Re: BusConnects Bray to City Centre Core Bus Corridor Scheme

Re: BRAY TO CITY CENTRE CORE BUS CORRIDOR SCHEME AND COMPULSORY PURCHASE ORDER 2023

Castlethorn and Chartered Land Group Submission on behalf of Aeval Unlimited Company with respect to proposed Permanent and Temporary Acquisition of Lands at Woodbrook, Shankill being Plot Ref. No. 1066(1).1h, 1066(2).2h

FIG 1: Option 1 Layout for Woodbrook entrance

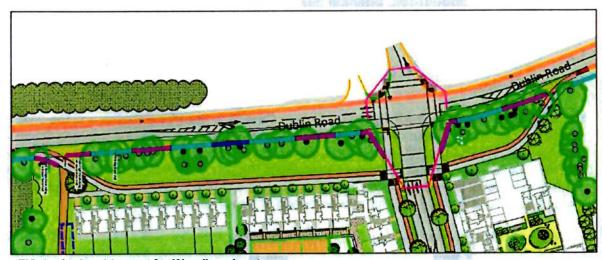
We invited An Bord Pleanala to determine the most appropriate entrance and interface arrangement with the Old Dublin Road noting our preference for Option 1. Condition No. 8 of our SHD permission (Ref. ABP-305844-19) deals with this matter, requiring as follows:

FIG 4: Overlay of Permitted Woodbrook Scheme with Proposed Permanent & Temporary Land Acquisition Plans as received from the NTA in March 2023.

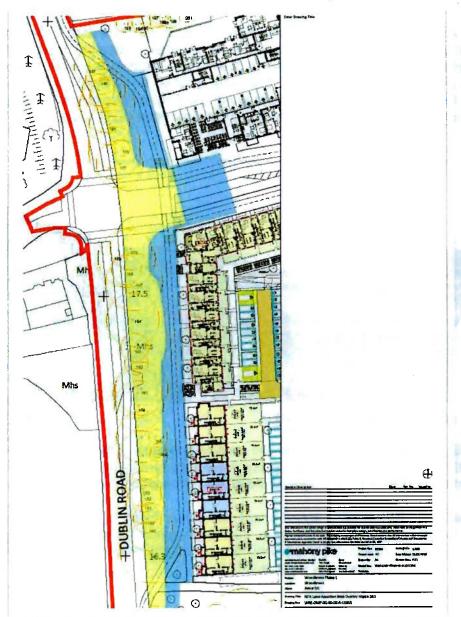
The extent of permanent and temporary land acquisition as indicated in the above plan based on hard copy, coloured plans (beige representing permanent landtake and blue representing temporary landtake) sent to us in March appears consistent with the Compulsory Purchase Order communication and accompanying plans as sent to us on 10<sup>th</sup> August 2023. We have concerns about the overlap of the proposed temporary acquisition on the footpath and private curtilage of houses and duplexes along that Old Dublin Road frontage and communicated those concerns to the BusConnects project team back in March and we will elaborate on those concerns in the next Section of this submission.

to get to the front door of these dwellings. One can see by reference to Fig 4 above that the blue infill area (extent of proposed temporary land acquisition) extends across the full extent of that existing footpath and adjoining cyclepath, which we submit should be retained and utilised to avoid duplication of pedestrian and southbound cycle facilities along the eastern edge of the expanded Old Dublin Road corridor.

We have concerns as noted with the BusConnects currently proposed design and its potential impact on the established sylvan character and existing entrance at Woodbrook and the residential amenity of those houses and duplexes that front onto the Old Dublin Road. We would respectfully submit that the footpath and southbound cyclepath along the eastern side of the upgraded Old Dublin Road should be retained in any event at that existing, recently constructed new alignment along the front of the Woodbrook site thereby reducing the continuous corridor width of the widened Old Dublin Road and avoiding the duplication of such pedestrian and cycle facilities so close to these permitted facilities as constructed on-site. The eastern extent of the BusConnects widened corridor, if dedicated bus lanes at this location are deemed essential, would thus be the southbound bus lane and bus stop with a pathway connection east from the bus stop to the adjacent footpath and cyclepath as existing at Woodbrook.

This slightly amended proposal, still accommodating dedicated bus lanes, would facilitate a wider 'green corridor' and buffer between the expanded Old Dublin Road and the adjacent Woodbrook development that would facilitate more meaningful landscape screening between this upgraded road corridor and adjacent residential development. We would further request that it be conditioned that the existing stone wall should be salvaged and rebuilt as appropriate along the eastern edge of the BusConnects works i.e. the eastern edge of the southbound bus lane with the necessary breakout to accommodate the planned bus stop and a pedestrian pathway east to connect to the existing pathway and southbound cyclepath as constructed within the Woodbrook scheme.

FIG 5: Extract from Landscaping Design Sheet 48 of 54

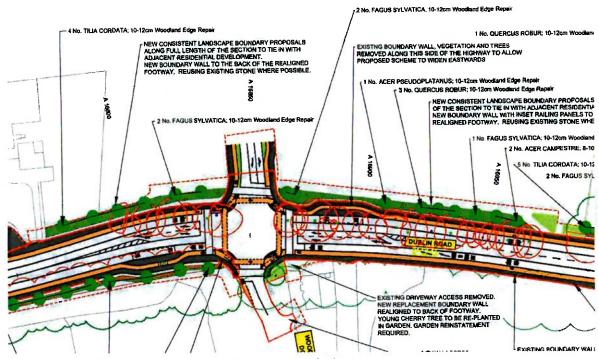
We are not reassured by the indicative hedge planting and intermittent tree planting suggested in that proposed Landscaping Plan and would respectfully request a widened 'green corridor' to serve as a more significant landscape buffer and a more intensively planted row of native new semi-mature trees of more significant girth to compensate for the very significant impact that the BusConnects works could have on the character and residential amenity of Woodbrook and on the otherwise continuous sylvan character of the Old Dublin Road.

Finally, we would respectfully request that it be conditioned that a significant number of semimature trees be planted within this widened 'green corridor' along its western edge to provide some meaningful natural screening between Woodbrook and the Old Dublin Road. This would be important to protect the residential amenity of adjacent dwellings and to try to compensate for the loss of existing mature trees along this section of the Old Dublin Road if they cannot be retained. This would go some way to re-establishing the sylvan character at the entrance to Woodbrook and maintaining that continuous, well-established, and attractive natural sylvan character along the Old Dublin Road.
